**NUMBER:** 18-011-13  
**GROUP:** Vehicle Performance  
**DATE:** March 06, 2013

Flash: MIL Illumination P050B and/or Rattle/Clatter Sound on Cold Start-up

2011 - 2013      MK                              Compass/Patriot

**Fig. 1 Purge Solenoid Wire Harness**

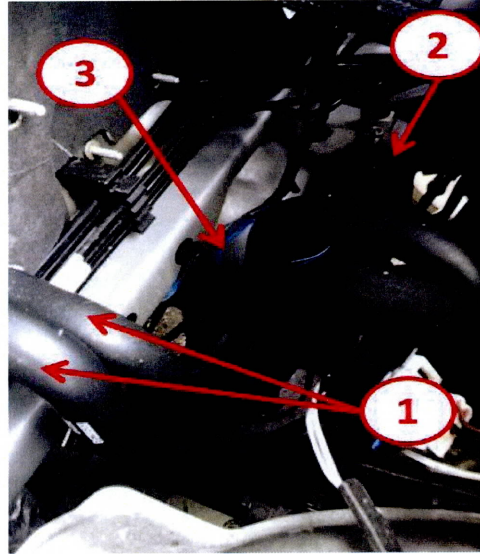
5. Without removing the pressure cap and with system not under pressure, turn draincock counterclockwise to open.
6. The coolant reserve bottle should empty first, then remove the pressure cap.
7. Allow cooling system to drain completely.
8. Remove both supply and return heater core hoses.
9. Install new heater core supply hose (p/n 05058822AB) and heater core return hose (p/n 05058823AB).
10. Install the right wheel inner splash shield.
11. Remove the engine cover.
12. To ensure that the purge solenoid wiring harness ([Fig. 1](#)) does not come in contact with the heater hoses, the wire harness will require a slight modification.

**Fig. 2** *urge Solenoid Wire Harness Routing*

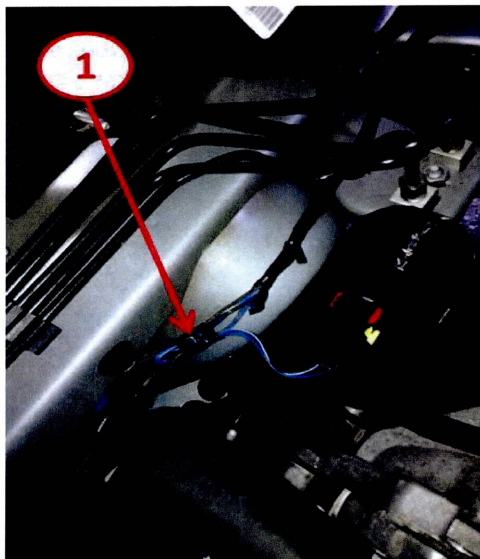
13. Loosely pull the purge solenoid wire harness straight and create a bend in the harness approximately 10mm (0.40 in. or 3/8 - 7/16 in.) away from the harness retaining clip edge. This bend will also create a natural bend after the current spot tape on the harness. Then, apply 3 - 4 wraps of electrical tape securing the bend to the harness as shown in (Fig. 2).
